5.0-VECC-8 ATTACHMENT 1 – ROMETOWN MAP

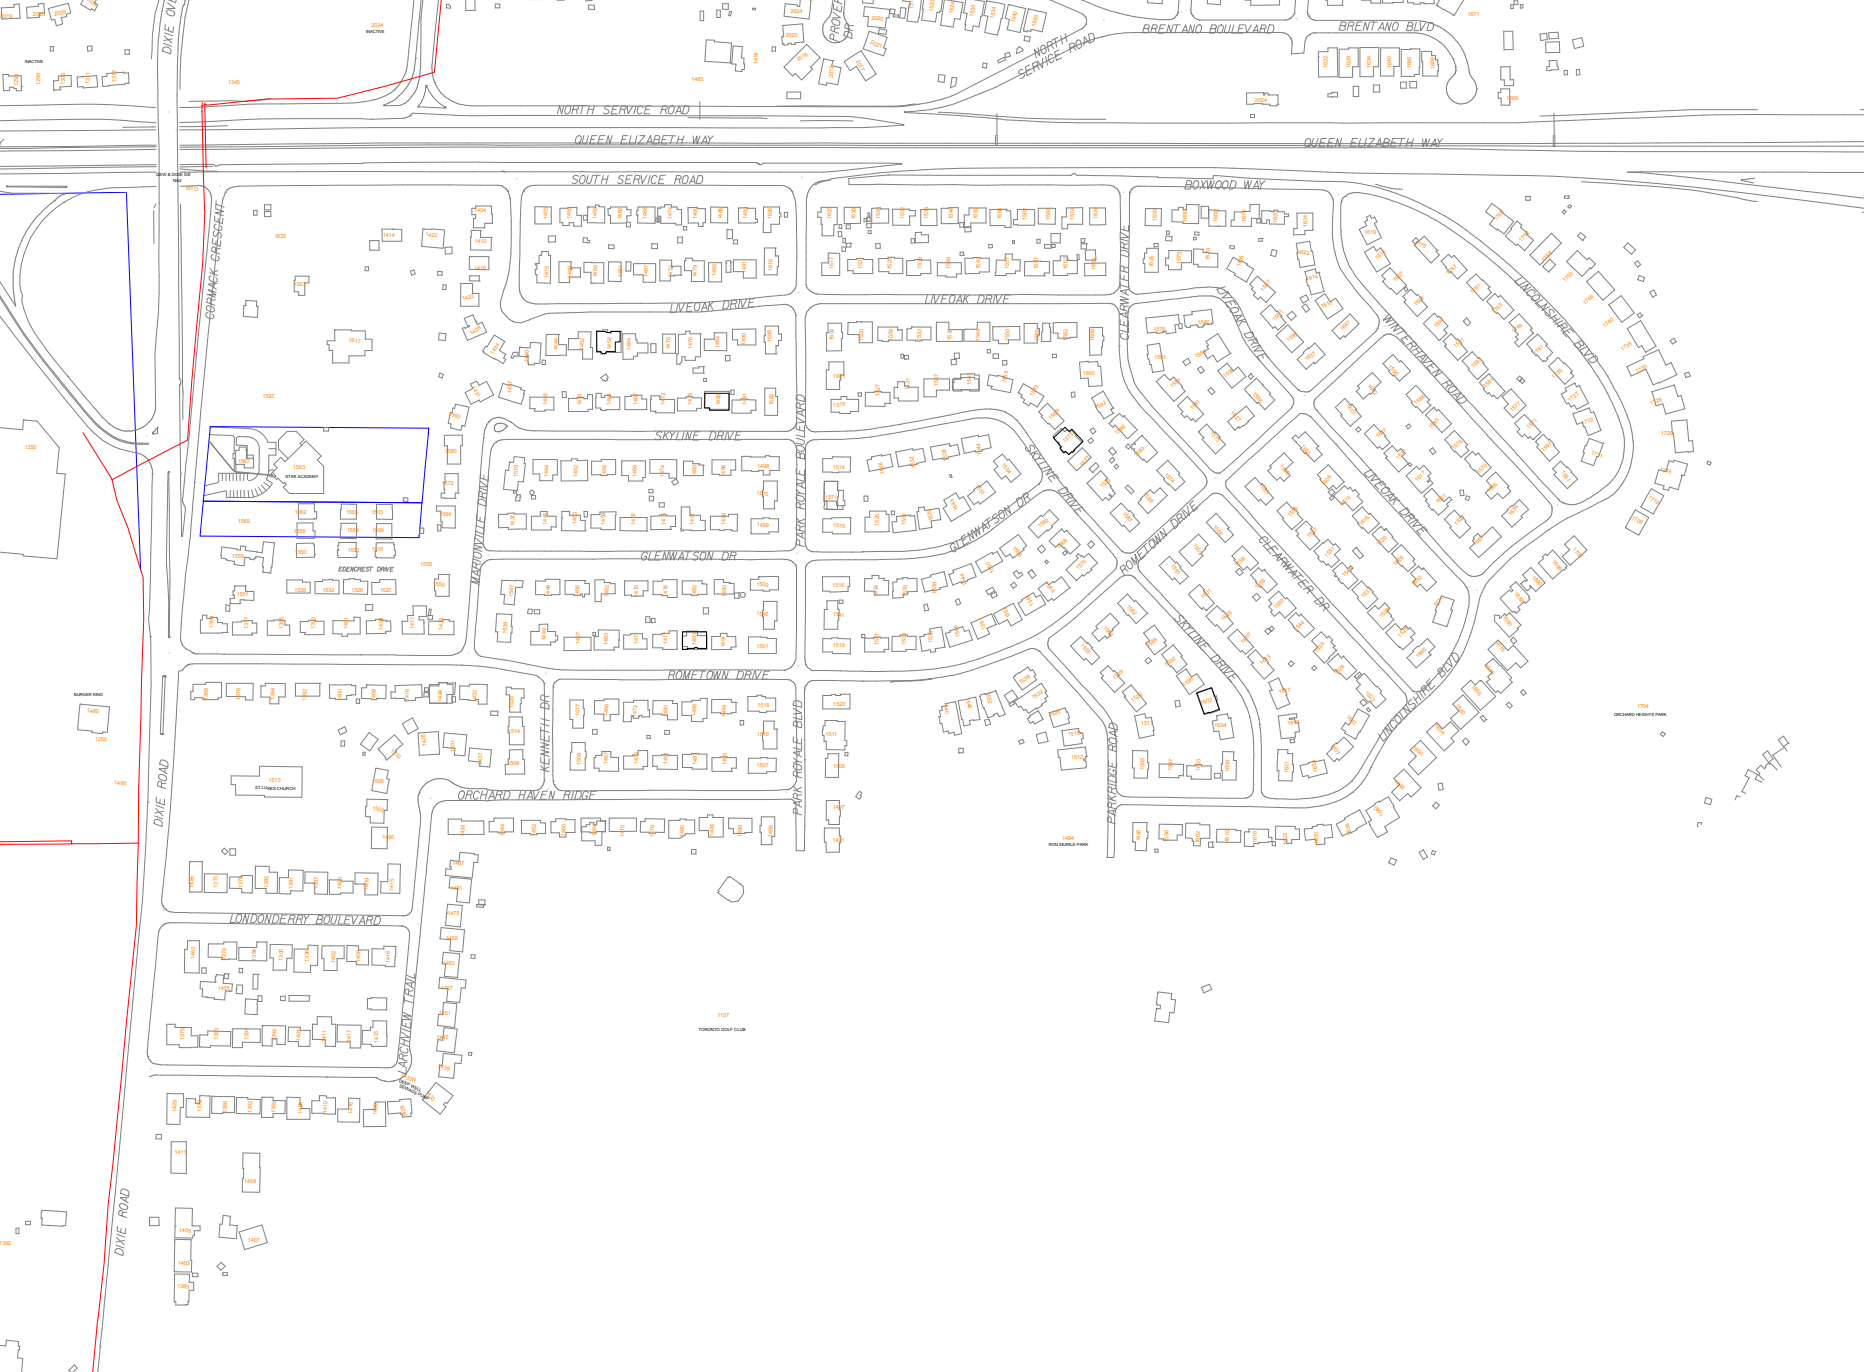
- a) Please provide a map showing the road bordering the area known as the Rometown project. Is this area also referred to as 'Orchard Heights'?**
- b) How many homes are served in the affected area?**
- c) Please explain in what fashion the Rometown project is atypical of annual capital programs which address reliability issues in the Enersource Rate Zone?**
- d) Please provide the annual capital spending in the Rometown area in each of the past 5 years?**

- 1 a) The map of the Rometown project site is provided as Attachment_5-VECC-
2 8_RometownProjectMap. The project area is immediately west of the area referred to as
3 Orchard Heights Park.
4
